Authorisation Application Form

Authorisation to prepare an amendment to the planning scheme under section 8A of the Planning and Environment Act 1987

PROPOSED MONASH PLANNING SCHEME AMENDMENT C159MONA

PROPOSED MONASH PLANNING SCHEME AMENDMENT C159MONA (FORMER BODY SHOP SITE)

Table 1a Maximum building height requirements for Precinct A and B

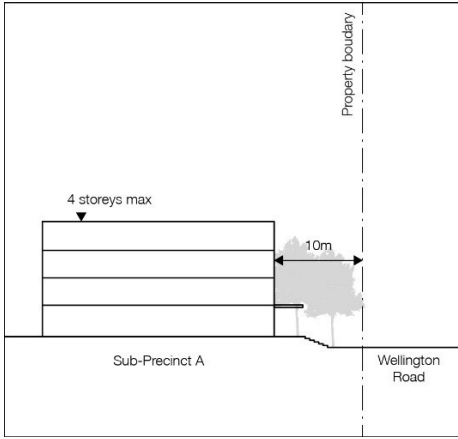
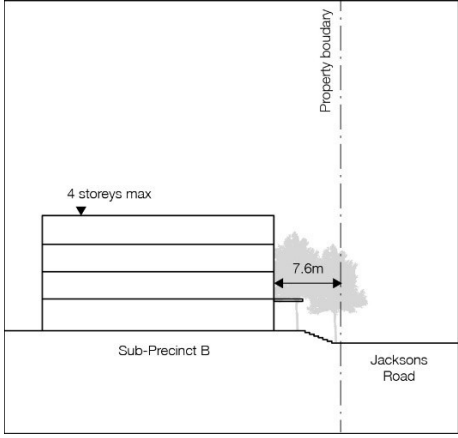
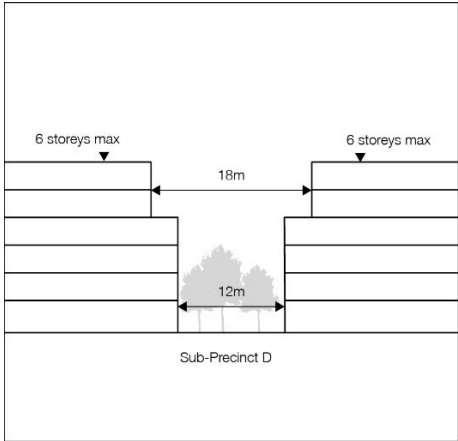
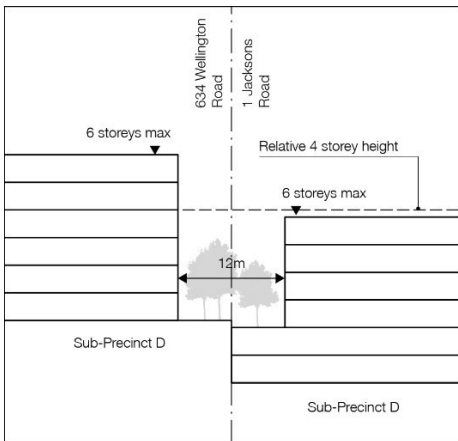
- In proposed Schedule 16 to the Design and Development Overlay:
 - Amend the headings in tables 1a, b and c to use the words 'Built form requirements' instead of 'Maximum building height'.

All the background work that has been undertaken to arrive at the built form requirements in Tables 1a, b and c is based on topographic assessments of the land in its existing, heavily modified topography. Removal this statement simply adds an additional element of uncertainty to any future planning application.

DELWP does not object to the proposal to identify the base ground levels from which heights are measured, however it needs to be done in a clear and unambiguous way. A better approach would be to specify the existing ground levels, possibly in the form of AHD figures, as part of the amendment and allow them to be interrogated through exhibition so in the future there is no question as to their accuracy.
